Groundwater Transfer Review Summary Form

Transfer/PA # T- 14560 (RA)

Application: T-14560

Applicant Name: Shortland Golf Club

Annotated Agent Cross Section- Annotations in red were made by the reviewing hydrogeologist, not the applicant's agent.

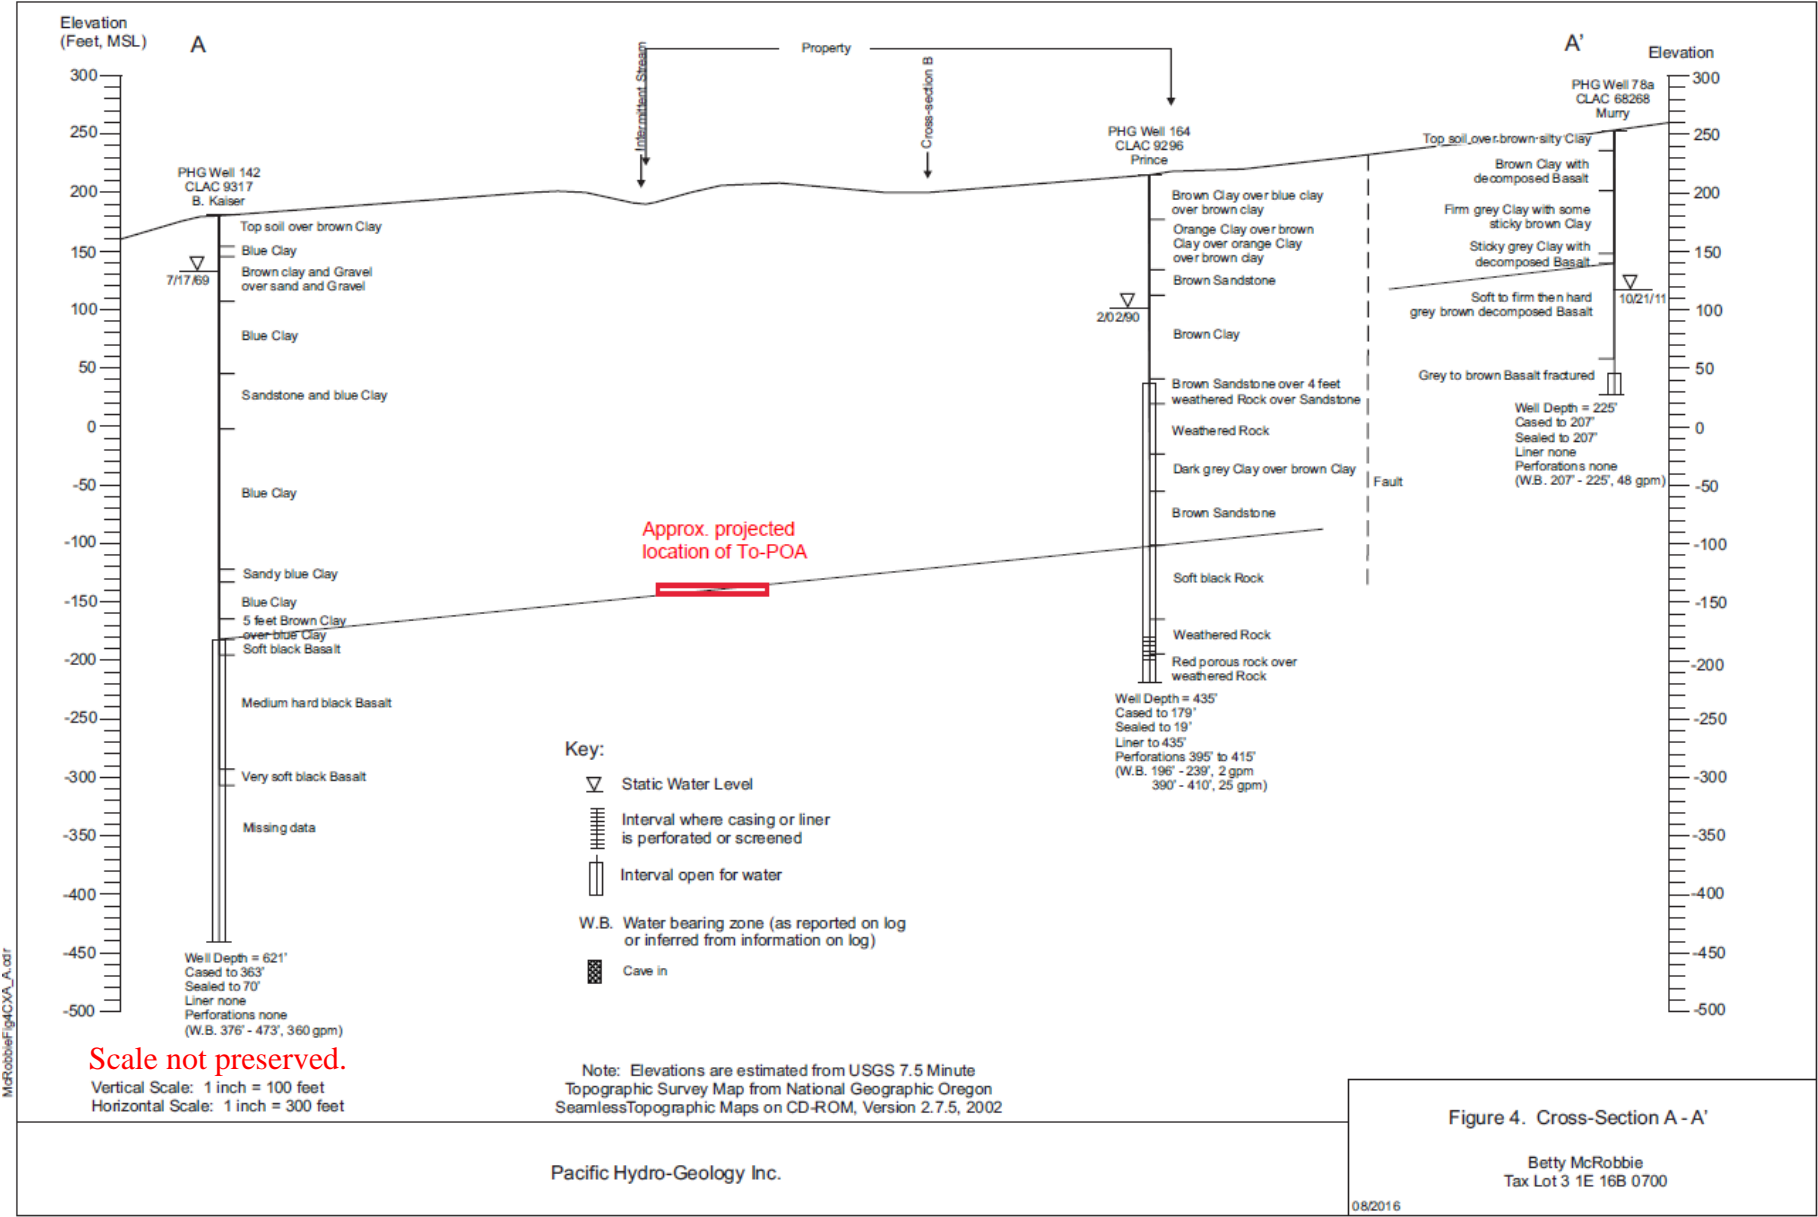
The To-POA is proposed to be completed to a total depth between 290 and 1000 ft bls, with casing and seal extending "0 to 5 feet into basalt." **NOTE: Current well construction regulations for sealing into consolidated formations (OAR 690-210-0150) require casing and seal extend to at least five feet into solid, unfractured, consolidated rock overlying the water-bearing rock formation.** The applicant's agent has provided analysis

indicating that, at the location of the proposed To-POA, the solid, unfractured Columbia River Basalt likely exists at greater than ~370-380 ft bls (~ -140 to -150 ft msl) based on the well reports for CLAC 9317 (authorized POA) and CLAC 9296 (neighboring well) (see attached Annotated Agent Cross Section). This largely agrees with the well report for CLAC 18564, which appears to be the closest well to the proposed To-POA and indicates weathered basalt from 357 to 363 ft bls (~ -113 to -119 ft msl) and more competent basalt from 363-370 ft bls (~ -119 to -126 ft msl). Based on the well report for CLAC 18564 and the land surface elevation at the proposed To-POA, the proposed To-POA would need to be cased and sealed to at least ~350 ft bls to meet well construction standards and only produce from the basalt aquifer. If constructed and sealed into the solid, unfractured basalt, the proposed To-POA will develop the same source as the authorized POA.

Hydrograph

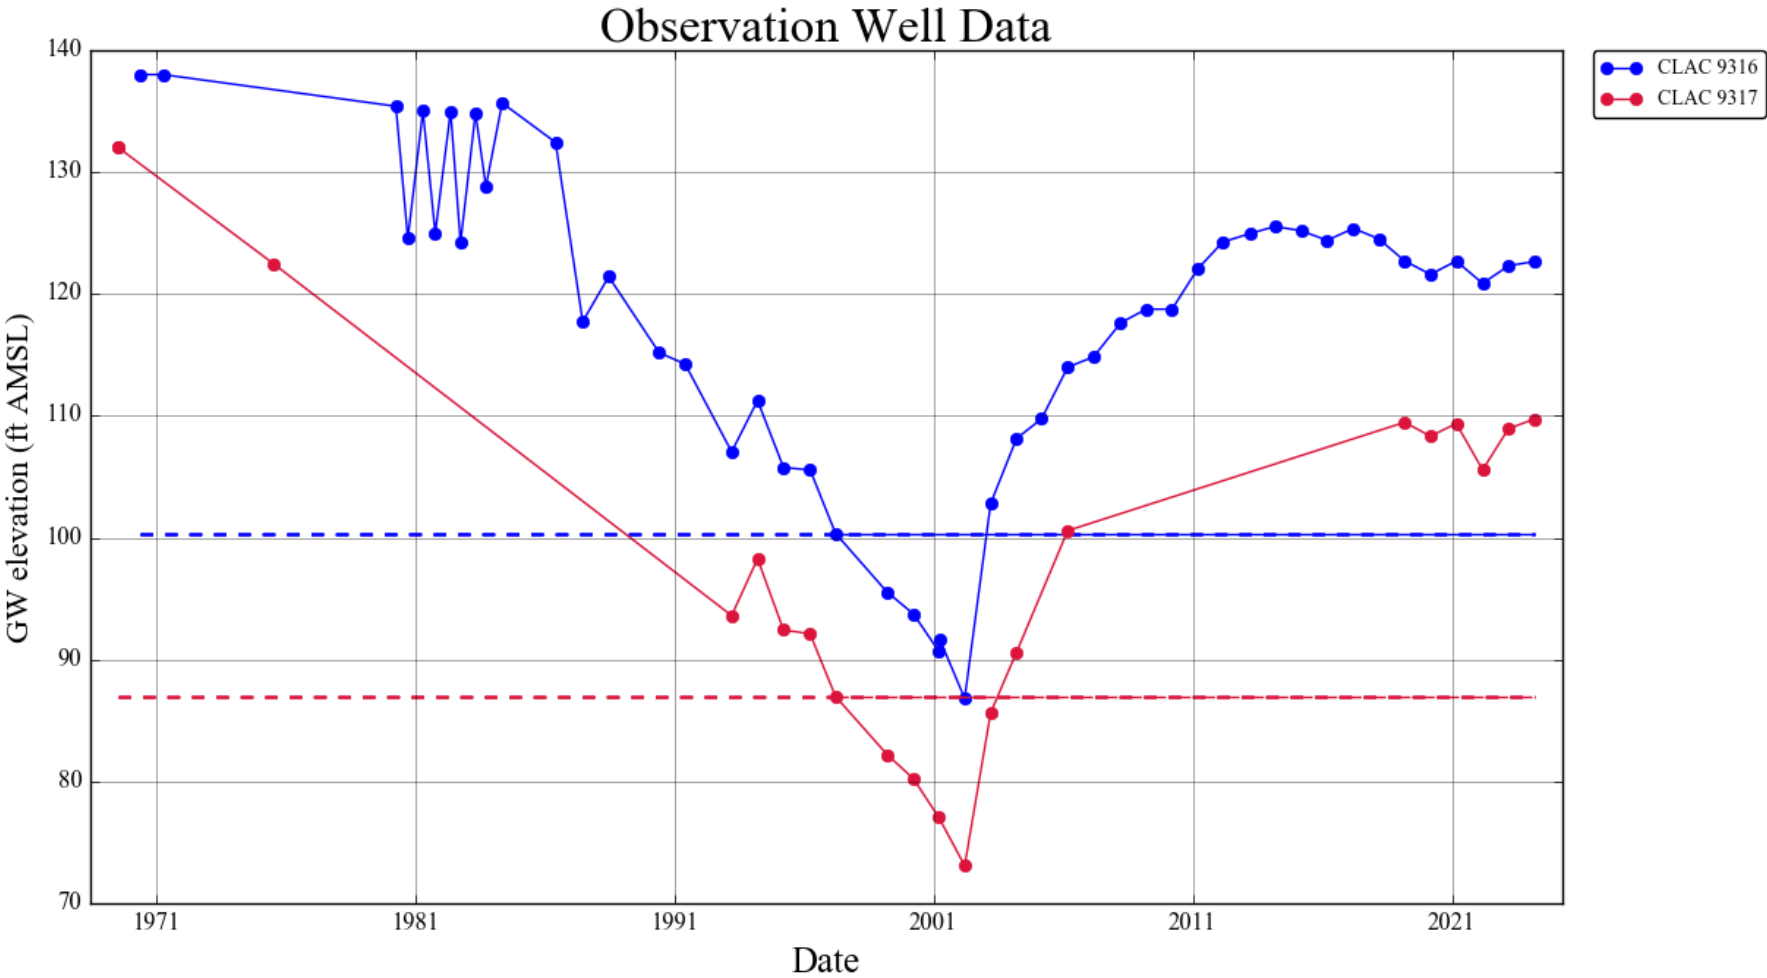
b) If yes, for each POA identify the reference level, most recent spring-high water level, and whether an applicable permit decline condition has been exceeded: The reference level for Well 1 (CLAC 9317) is 93.03 ft bls and for Well 2 (CLAC 9316) is 99.65 ft bls. Although both wells briefly exceeded their permit decline conditions in 2002, they have since recovered substantially and appear more stable in recent years (see attached Hydrograph). The exceedance of the decline conditions in 2002 and subsequent recovery were likely the result of the City of Wilsonville ceasing use of their basalt supply wells around this time. The reference level for the proposed Pond Well (To-POA) will be determined based on the hydraulic gradient between the proposed Pond Well and Well 2 (CLAC 9316) after the Pond Well is completed and the first annual water level measurement is submitted as required by the permit conditions.

Well Interference Analysis – Proposed Pond Well (To-POA) to CLAC 18564

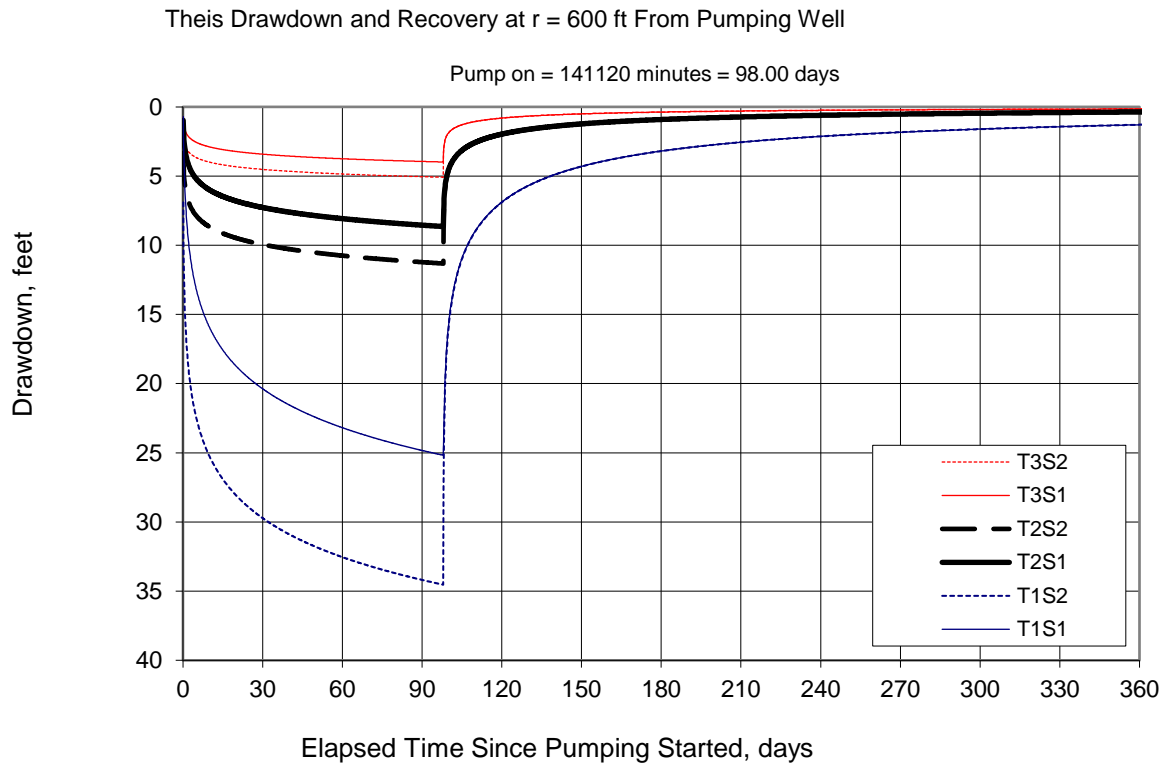
☐ Yes ☒ No If yes, explain: The potential interference between the proposed To-POA and CLAC 18564 was evaluated at the maximum combined rate of 0.473 cfs using the Theis (1935) solution for drawdown in a confined aquifer (see attached Well Interference Analysis). Based on the results of the analysis, the proposed change is unlikely to result in injury to CLAC 18564 or similarly located basalt wells.

Radial distance, $r = 600$ ft [approximate distance from To-POA to CLAC 18564]Pumping time, $t_{\text{pump}} = 98$ days [approx. time to exhaust duty under Permit G-18861 at 0.4 cfs]Pumping rate, $Q = 0.473$ cfs [maximum combined rate under T-14377 and T-14560]Transmissivity, $T1 = 800 \text{ ft}^2/\text{d}$ | $T2 = 2,800 \text{ ft}^2/\text{d}$ | $T3 = 6,800 \text{ ft}^2/\text{d}$ [Pumping Test Reports]Storativity, $S1 = 0.001$ | $S2 = 0.0001$ [Conlon et al., 2005]
